Subject: Objection to A/38/18/RES -Manor Nursery

Please find attached my OBJECTION to planning application A/38/18/RES.

Diagram 1. Dimensions of people and equipment

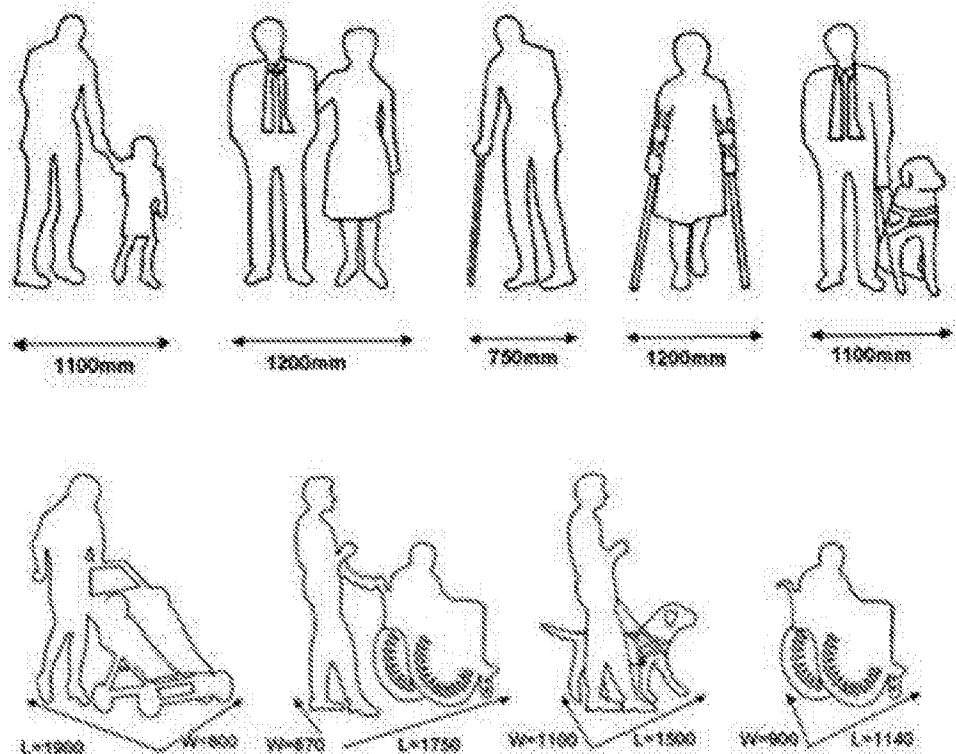
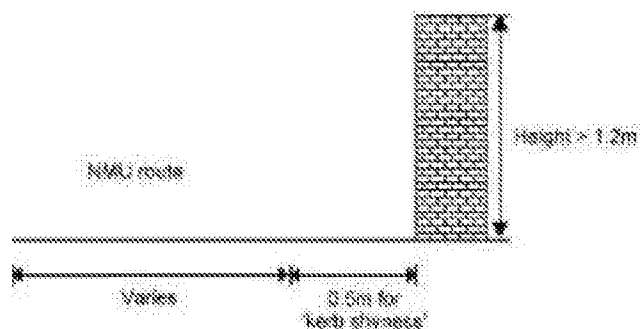
The High Street as a rural lane used by the local community e.g. families, dog walkers, parents with pushchairs and young children cyclists, joggers, horse riders etc. It provides access to the Spotted Cow public house as well as to the SDNP. The **Manual for Streets** says: “Streets where people walk in groups need wider footways”. This is certainly the case along the High Street. The image below gives dimensions of different types of user, NOT the width of the footpath.

Guidelines also recommend that an extra 0.5m should be added to allow for 'kerb shyness' where a footpath is bounded on one side by a wall or hedgerow more than 1.2m in height. Such as the boundary walls in front of Littleworth cottages and the Spotted Cow.
